Date: January 4, 2024

From: Tim Schwecke, Zoning Administrator

Subject: Final development plan for a proposed planned development district consisting of 145 apartment units located on the south side of Main Street; Sawall Development, applicant

Application: 2023-37; <https://s.zoninghub.com/C1GJTZ5DB4>

DESCRIPTION:
 PROPOSED
 SITE PLAN

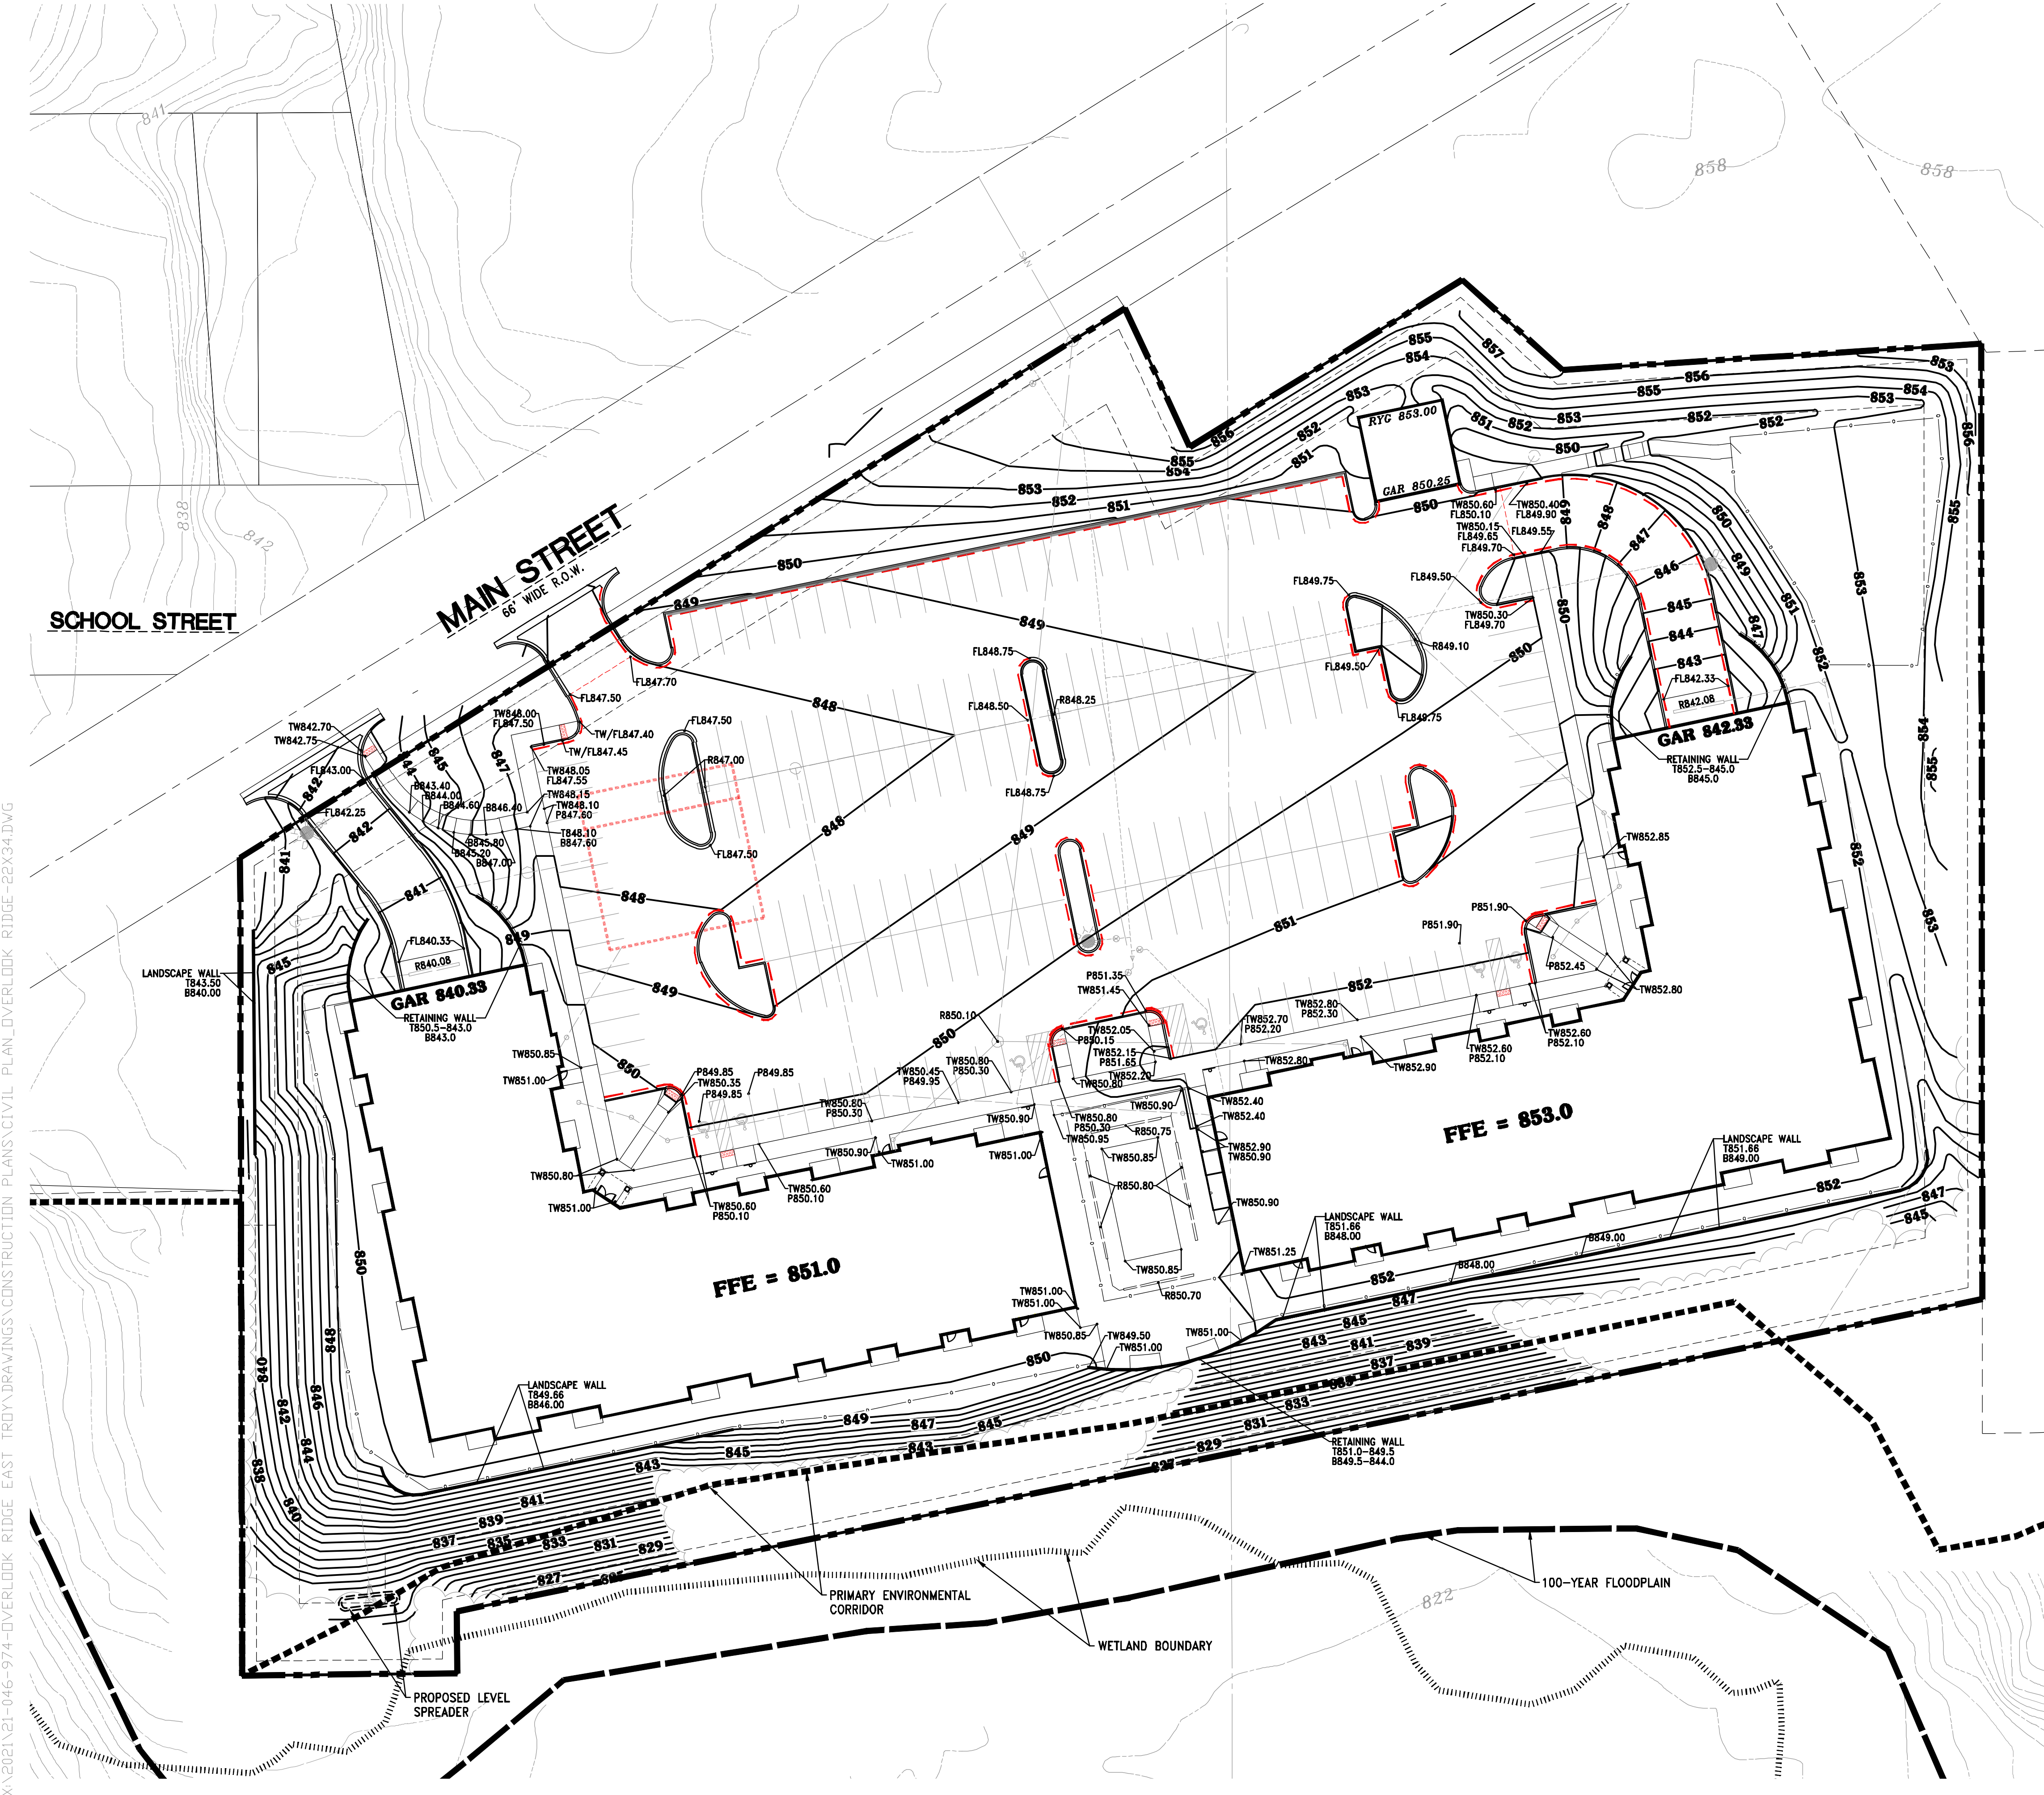
Fire department access The site plan should be revised to show the fire department (walking) access on the back of the proposed buildings, including the minimum distance from the wall, minimum width and maximum slope (as agreed upon with developer at the staff level). Several sheets depict the turning movements of a WB-50 truck and a typical fire truck.

LANDSCAPE - WEST PLAN PAGE

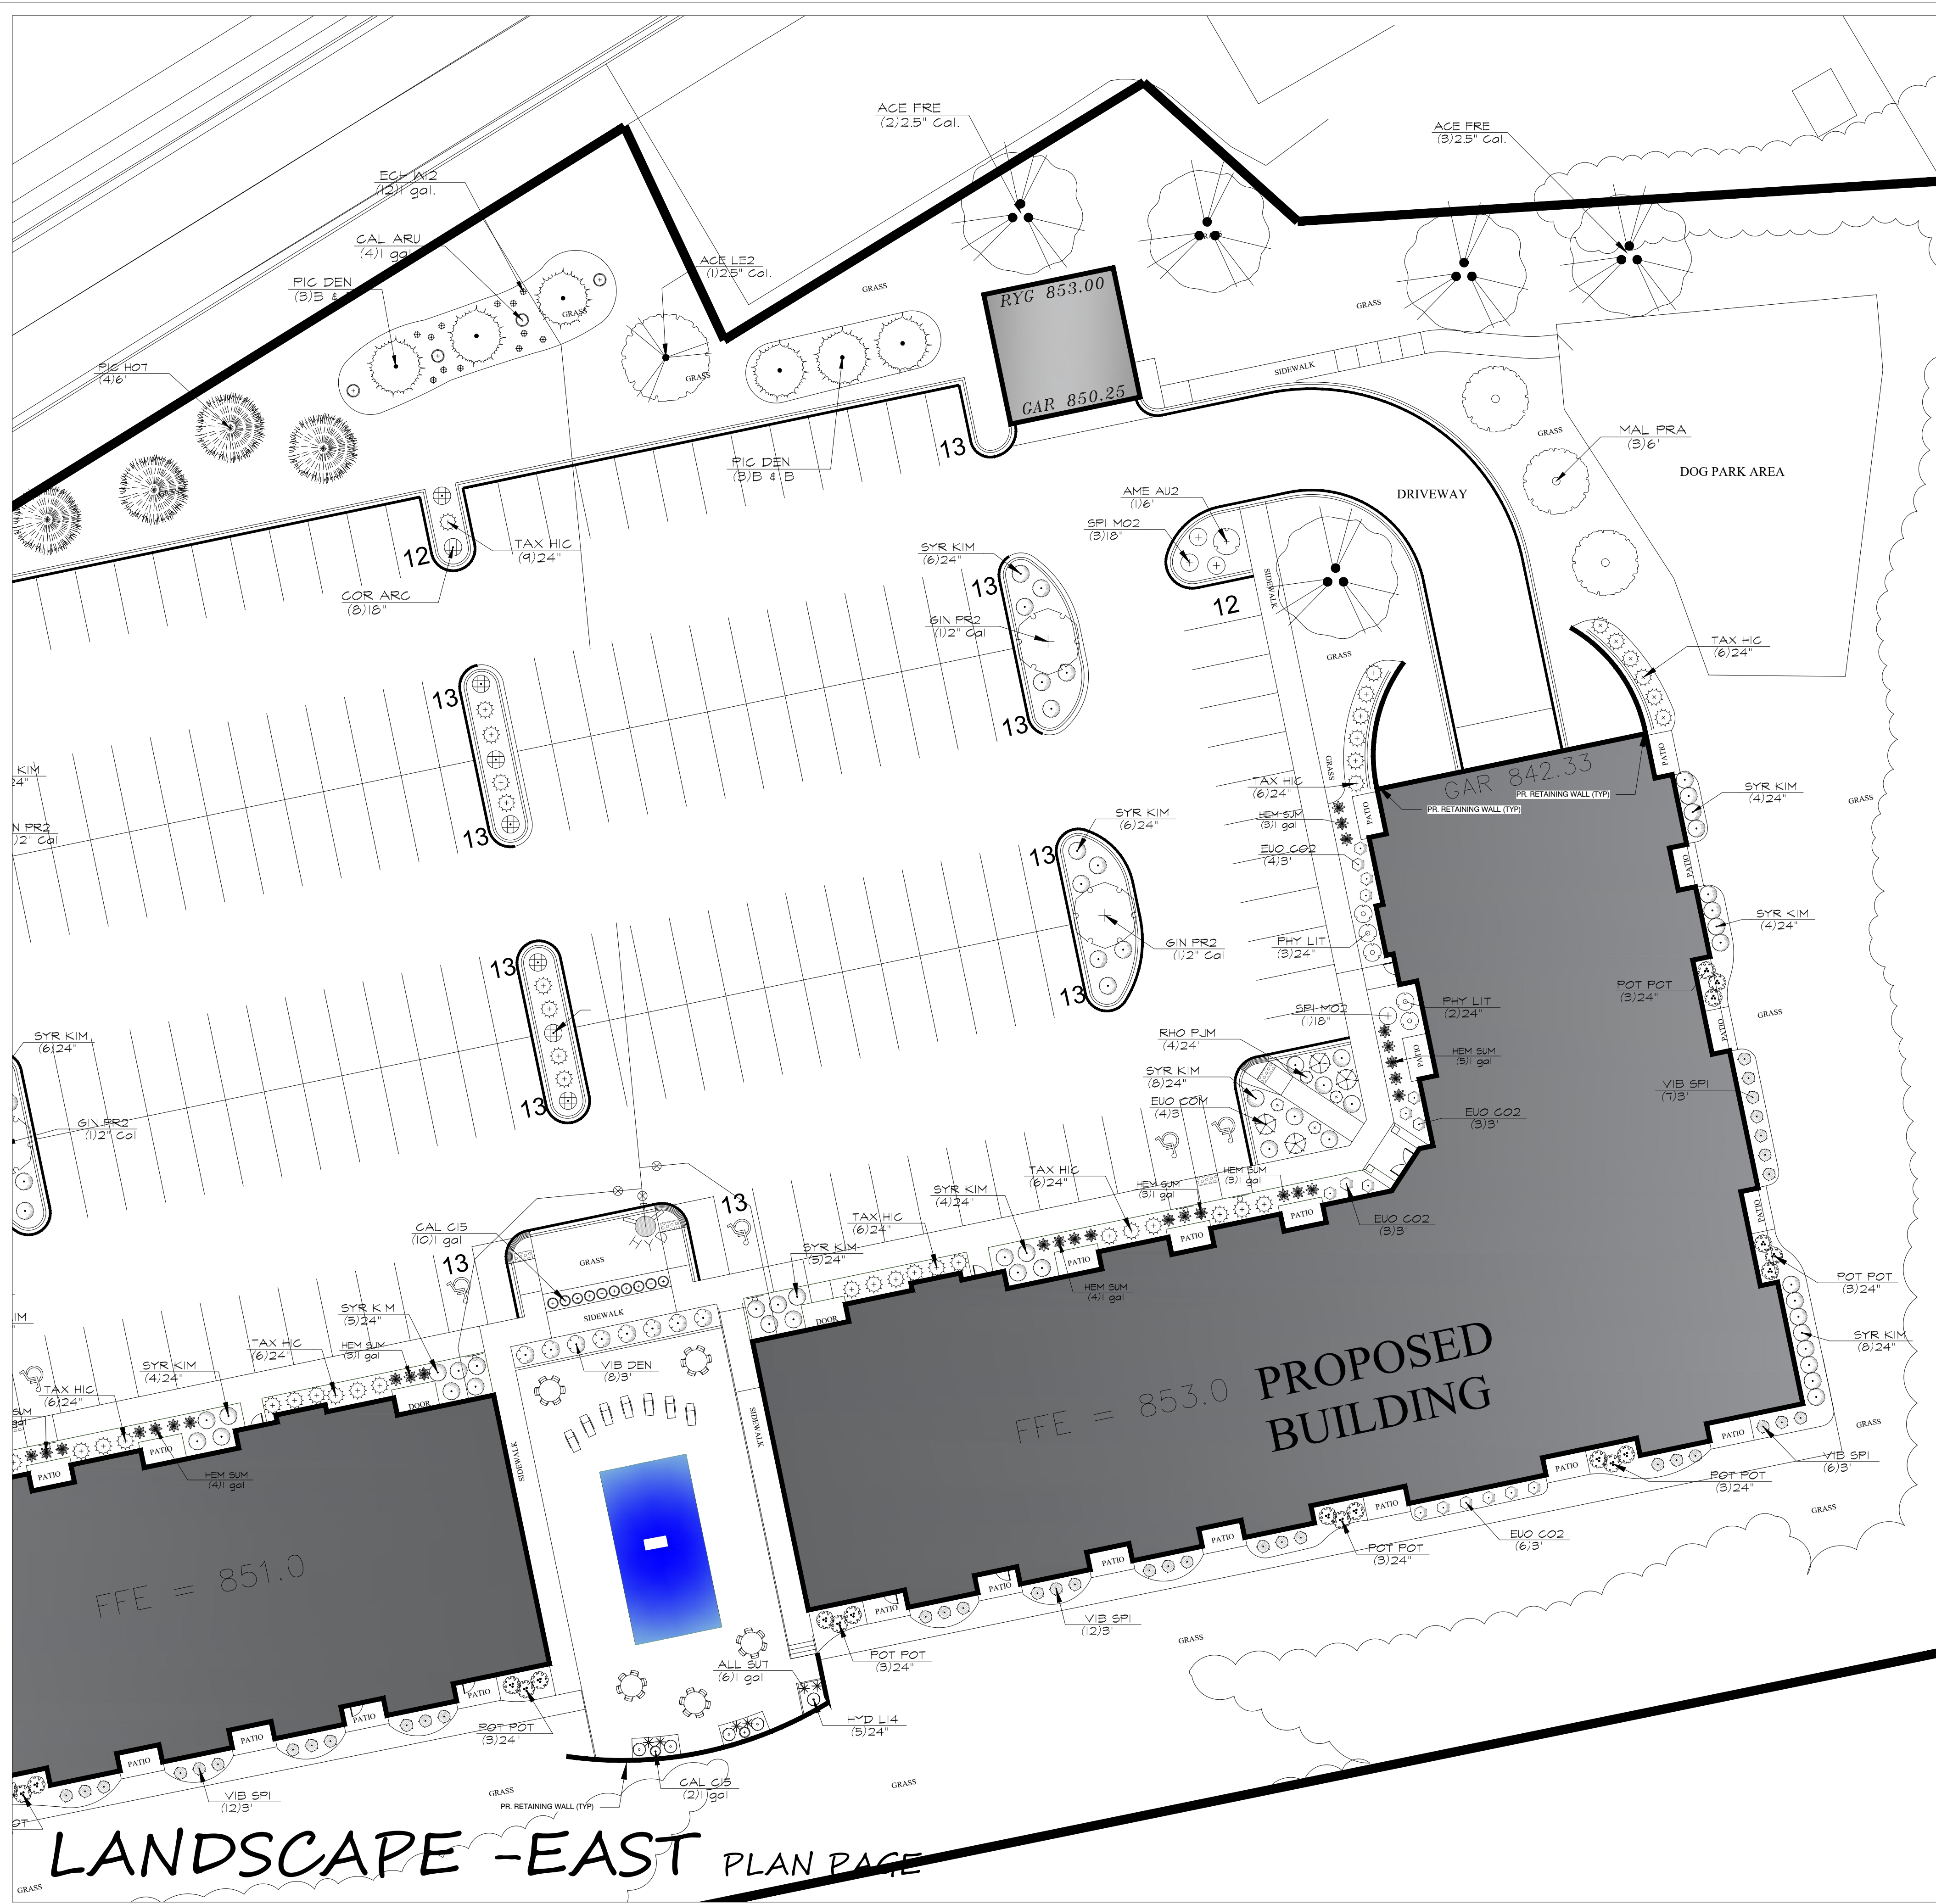
Landscaping and bufferyard A bufferyard with an opacity value of 0.4 must be located along the lot line with the single-family parcel to the west. That bufferyard must be depicted on the landscape plan (minimum width of 35 feet with 349 landscape points per 100 feet).
